### Development Assessment

**Subject:** DA2019/0309 – 257 Whale Beach Road, Whale Beach

**Record Number:** 2019/686357

**Figure 1.** Section through the proposed dwelling west to east demonstrating height (8.5m and 10m height limits) and slope of site.

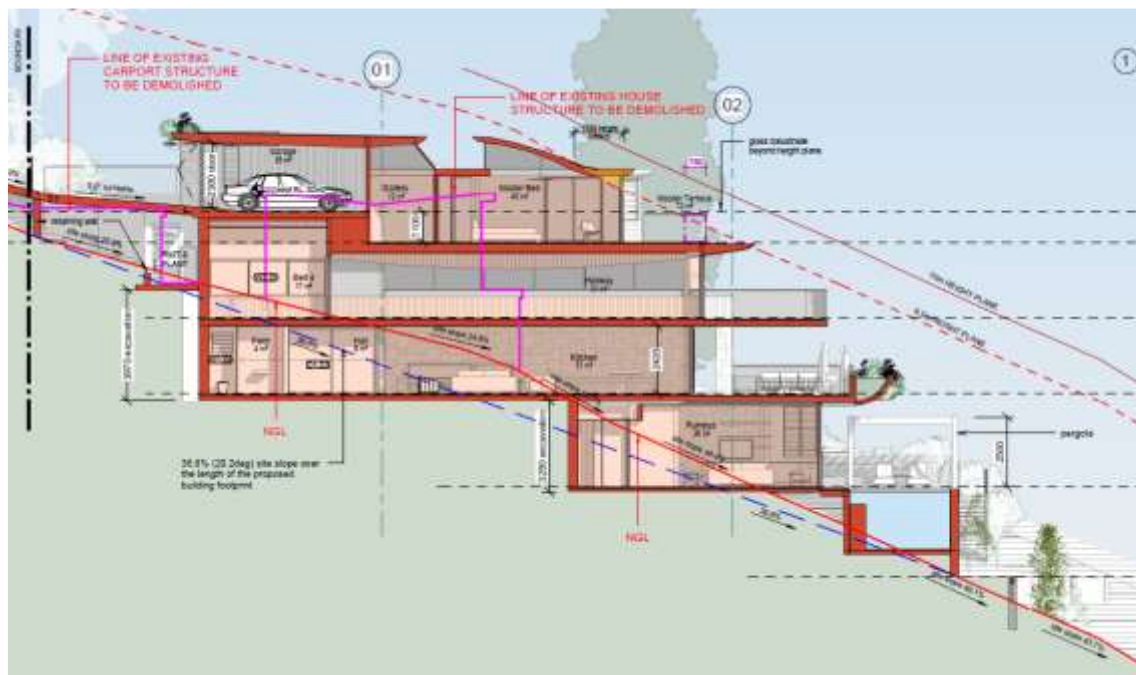
Comment: The site is located on the downward slope of the Whale Beach Road (eastern side) which is characterised by undulating topography to Whale Beach. This results in variable built forms in the area, such that there is an eclectic mix of height and scale in which to be compatible with.

The building height of the proposed dwelling varies from 5.6m - 9.5m, which demonstrates compliance with the height of buildings (8.5m – 10m) given the slope of site being developed is greater 30% (Clause 4.3(2D)).
